## **2.0 PROJECT DESCRIPTION**

### **2.2 OVERVIEW OF PROJECT AND REFINEMENTS**

# CAMBRIA DESALINATION FACILITY Regional Vicinity Map

Exhibit 2

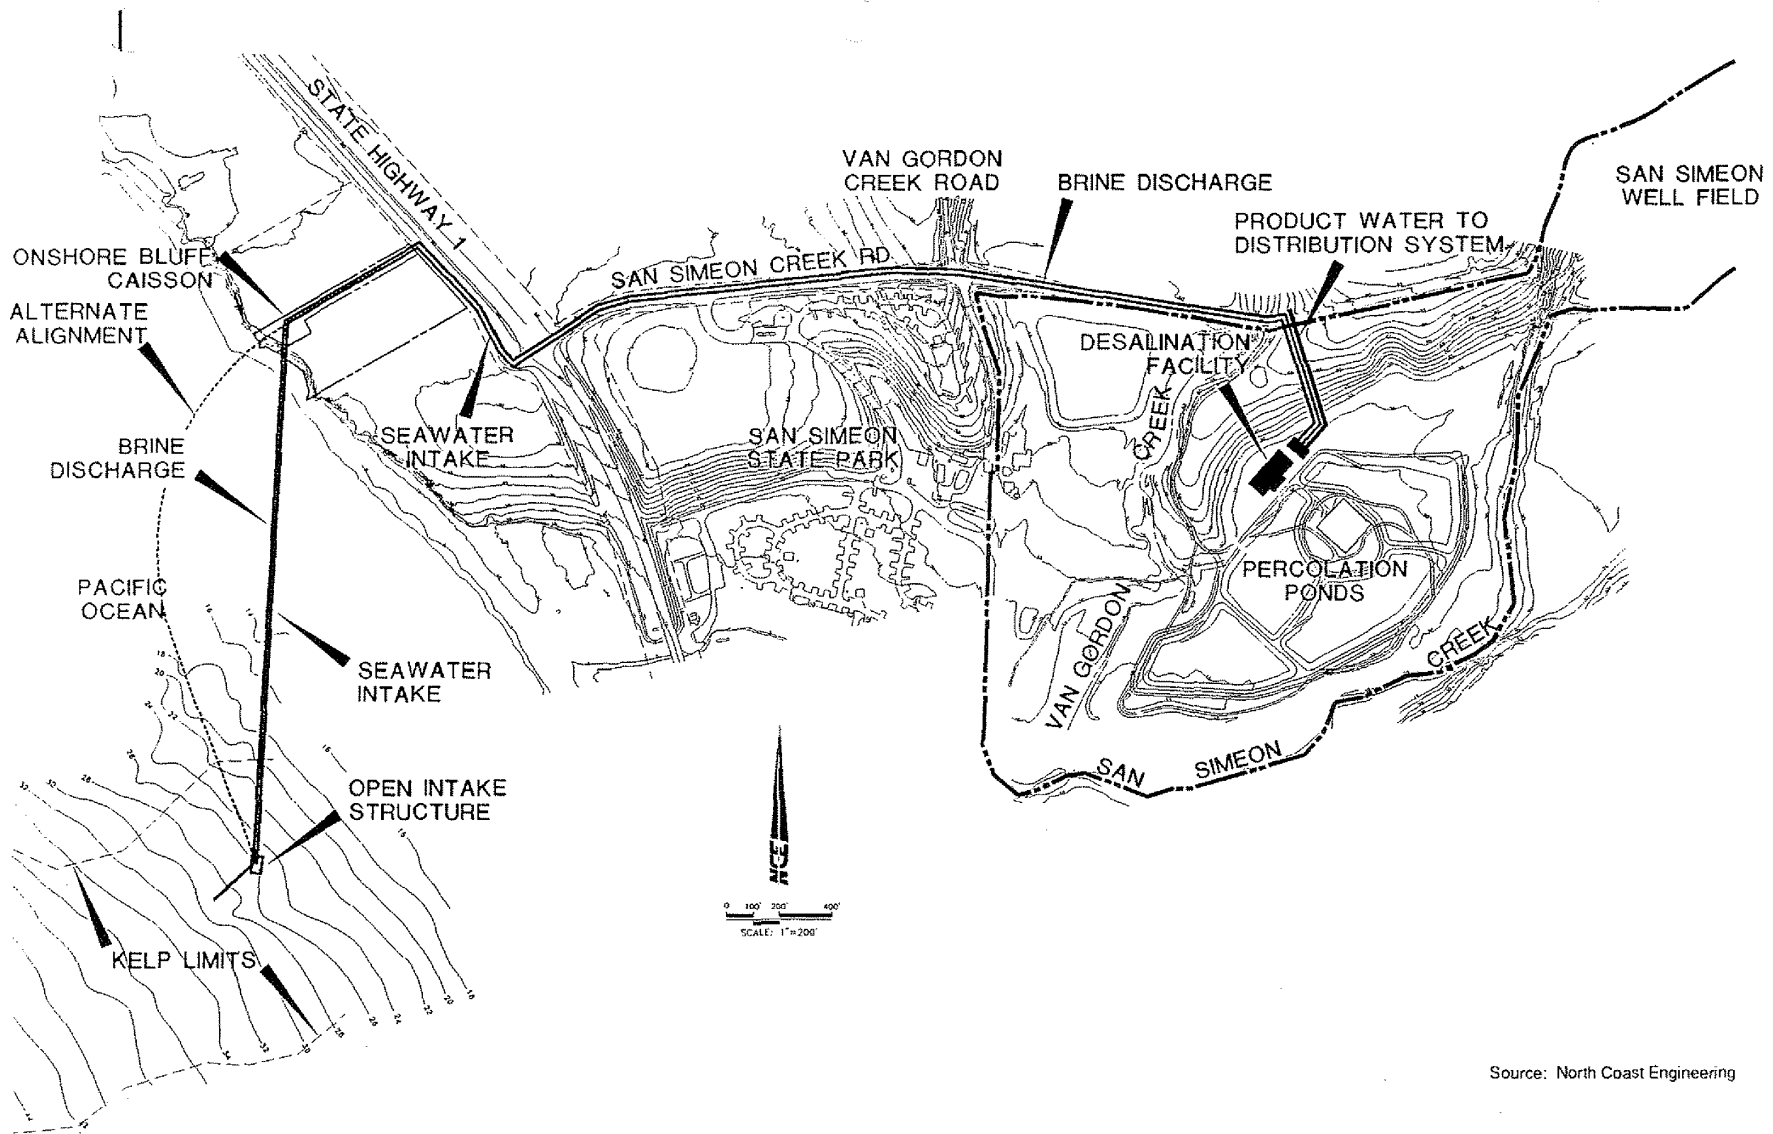
The overall project site is shown on Exhibit 2, Project Schematic. The off-shore feedwater and brine discharge facilities are located approximately 2,000 feet, along the pipeline alignment, offshore of San Simeon Creek. This is consistent with the Final EIR project description. The feedwater intake structure, as shown on Exhibit 3, consists of concrete bases supporting two

cylindrical intake screens. The brine discharge structure consists of 100 feet of sealed pipeline followed by an additional 100 feet of diffuser section supporting approximately 21 diffuser jets.

Exhibit 3

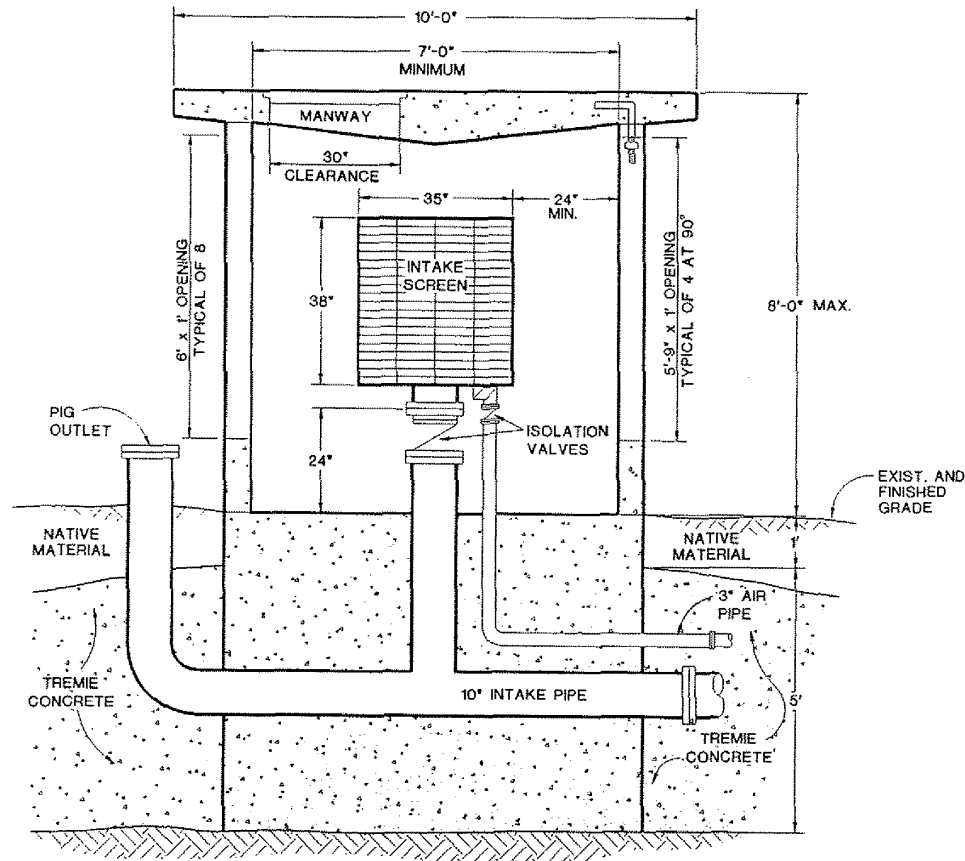
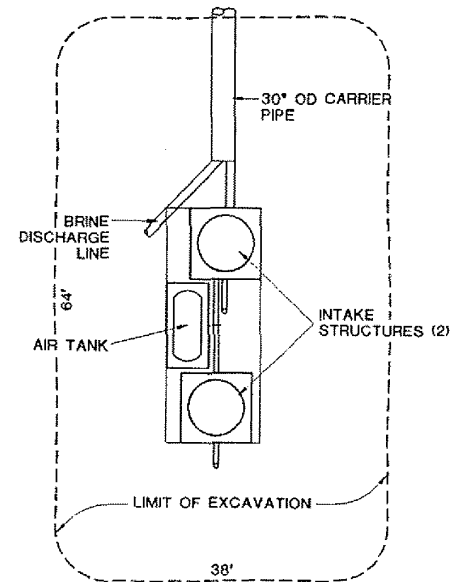
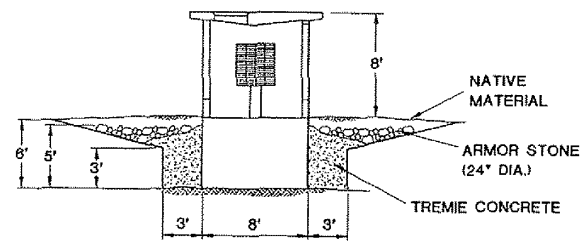
The intake structure will consist of a system of two intake screens, a pre-cast concrete base for each screen (approximately 8' x 8' x 6') connecting pipelines and a screen backwash air accumulator and piping. The intake structure will also include their ancillary components, such as valves and a clearing port. The height of the intake structure will be approximately eight feet. The base of the structure will be located in approximately 25 to 30 feet of water.

The concrete base structures will be pre-manufactured on shore and barged to the site. To resist wave, current and sediment transport forces, the base must be buried into the bottom sediments approximately six feet and be constructed of a weight and size to insure stability during turbulent ocean conditions. Excavation will consist of approximately 230 yards for the precast structure and excavation necessary for laying back slopes adjacent to the precast structure. The 230 cubic yards of marine sediment will be excavated and transported to shore for disposal in accordance with regulatory requirements. To secure the foundation and reduce the potential for scour, the over-excavated area adjoining the base will be backfilled with approximately 100 cubic yards of concrete. The concrete backfill will be poured to an elevation lower than the precast section, so that native backfill can be used to re-establish existing ground contours and bottom conditions adjacent to the structure. The design engineer may require driven concrete piles to support the precast structure. It is estimated that installation of the intake structure will require approximately 20 days. During this time, the derrick barge will remain anchored in one location and divers will monitor the placement of all anchors.

Exhibit 4

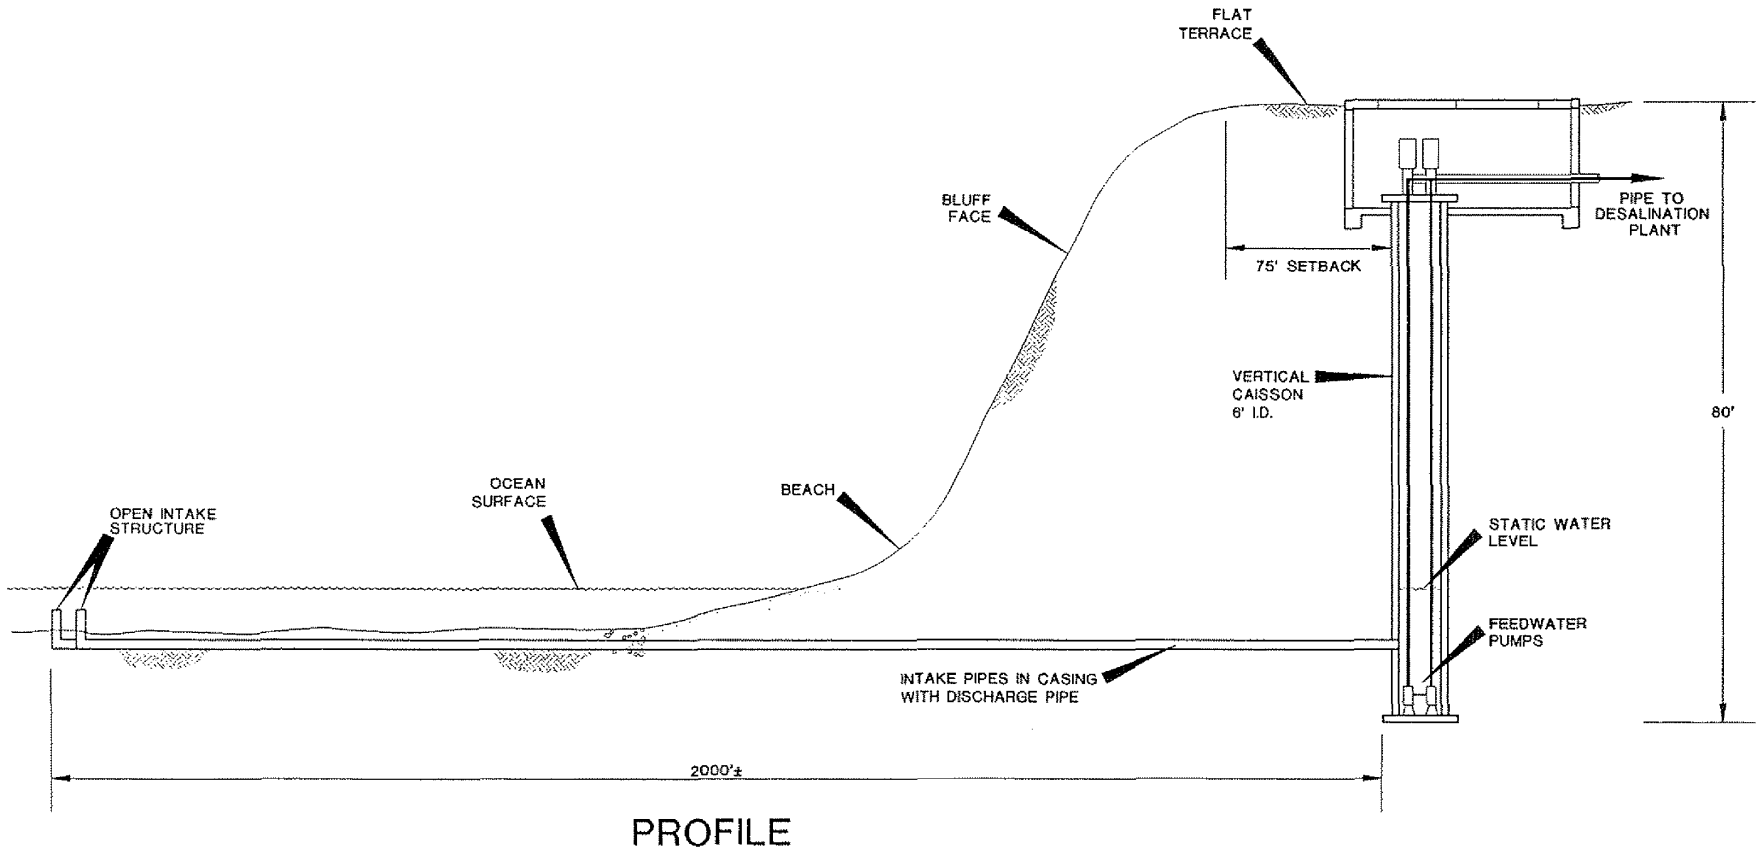
The offshore direct intake structure is connected to an on-shore bluff caisson, as shown on Exhibit 4, Bluff Caisson Profile, with two 10 inch pipes which are contained in an underground tunnel. The same tunnel pipe will house a separate 10 inch line to carry the brine discharge water from shore to the diffuser section. With the exception of the intake structure and diffuser pipe, all of the facilities are constructed beneath the surface of the ocean floor using directional drilling techniques, thus eliminating any disturbance to the ocean floor and sensitive biological habitat.

Located on a small flag lot, set back approximately 75 feet from the edge of the bluff, a minimum six-foot diameter on-shore bluff caisson will be constructed. This structure will serve primarily as the onshore terminus for the offshore to onshore pumping stations and as a feedwater pump station. The caisson will be drilled to a depth of approximately 80 feet by an auger-type drill and approximately 388 cubic yards of earth material will be removed from the bluff caisson construction. The concrete lined shaft will be fitted with the intake and discharge pipes and associated equipment. Once the necessary piping is installed at the bottom of the shaft, it will be backfilled with gravel to within approximately 10 feet of the ground surface. Sitting on top of the shaft, just below ground level, an equipment and control area will be constructed. Access to this below ground area will be by a small access hatch. It is anticipated that construction of the bluff caisson will require approximately 55 days.

A tunnel will be drilled from the bluff caisson to the offshore intake and discharge facilities to house both feedwater and brine reject pipelines. Two 10-inch feedwater pipeline and a single 10-inch brine reject water pipeline will be located in a minimum 30-inch (outer diameter) pipeline casing for protection (also referred to as an annulus pipeline). Both the casing pipe and the main transport pipes will be constructed of non-toxic, non-corrosive plastic piping.

The 30-inch minimum casing for the off-shore to on-shore pipes will be installed using the horizontal directional drilling (HDD) process. Horizontal directional drilling allows the drill rig operator located on shore to control the horizontal and vertical alignment of the drilling head to bore a tunnel under the ocean floor. Duration of the drilling will be approximately 30 days.
